Access Compliance Report

Public Rights-of-Way

(Pedestrian Signals)

Intersection ID: N/A	Main Street:	Cross Street: N/A	Location: N/A
ADA ID: 438636705191	Signal Type: Two Push Buttons-Non APS	Overall Compliance: No	Severity Score: BTN 1:N/A BTN 2: N/A No BTN: N/A
Codes/Mitigation Info/Possible Solution		Field Measurements/Component Compliance

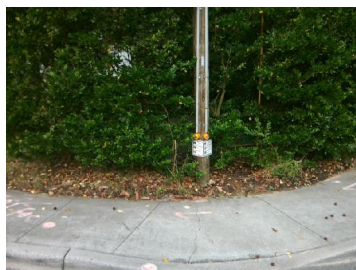
PROW/ADA: R404.2, R406.2, R404.3, R404.7.3

Compliance	Description	Data	Compliance	Description	Data
	Button Count	Button2	N/A	Distant to Additional Button (in)	N/A
	Additional Button Present?	No		Additional Button ID	N/A
N/A	Signal Buttons Required?	N/A	N/A	Additional Ped Posts Required	N/A
	How Many Ped Street Xings?	2		Located In An Island/Median?	No
N/A	B 1 Sign Present?	Yes	N/A	B 2 Sign Present?	Yes
Yes	B 1 Sign Purpose?	Yes	Yes	B 2 Sign Purpose?	Yes
Yes	B 1 Sign Lettering & Contrast?	Yes	Yes	B 2 Sign Lettering & Contrast?	Yes
Yes	B 1 Parallel To XWalk?	Yes	Yes	B 2 Parallel To XWalk?	Yes
Yes	B 1 PAR to Button?	Yes	Yes	B 2 PAR to Button?	Yes
Yes	B 1 PAR to XWalk?	Yes	Yes	B 2 PAR to XWalk?	Yes
Yes	B 1 Clear Floor Space?	Yes	Yes	B 2 Clear Floor Space?	Yes
N/A	B 1 FWD Approach?	Yes	N/A	B 2 FWD Approach?	Yes
N/A	B 1 FWD Approach Constrained?	No	N/A	B 2 FWD Approach Constrained?	No
No	B 1 FWD Approach Reach (in)	10.0	No	B 2 FWD Approach Reach (in)	11.0

N/A	B 1 FWD Approach Width (in)	N/A	N/A	B 2 FWD Approach Width (in)	N/A
N/A	B 1 FWD Approach Obstruction?	No	N/A	B 2 FWD Approach Obstruction?	No
N/A	B 1 FWD Approach Obstruction Dist (in)	N/A	N/A	B 2 FWD Approach ObstructionDist (in)	N/A
N/A	B 1 PARA Approach?	Yes	N/A	B 2 PARA Approach?	Yes
N/A	B 1 PARA Approach Constrained?	No	N/A	B 2 PARA Approach Constrained?	No
Yes	B 1 PARA Approach Reach (in)	10.0	No	B 2 PARA Approach Reach (in)	11.0
N/A	B 1 PARA Approach Width (in)	N/A	N/A	B 2 PARA Approach Width (in)	N/A
N/A	B 1 PARA Approach Obstruction?	No	N/A	B 2 PARA Approach Obstruction?	No
N/A	B 1 PARA Approach Obstruction Dist (in)	N/A	N/A	B 2 PARA Approach ObstructionDist (in)	N/A
Yes	B 1 Clear Floor Space Slope (%)	3.7	No	B 2 Clear Floor Space Slope (%)	2.8
No	B 1 Clear Floor Space XSlope (%)	6.2	No	B 2 Clear Floor Space XSlope (%)	5.5
N/A	B 1 PAR Slope (%)	7.8	N/A	B 2 PAR Slope (%)	1.4
Yes	B 1 Height (in)	33.0	Yes	B 2 Height (in)	33.0

Possible Solutions: Provide Push Button Extension. Remove and Replace Clear Space.
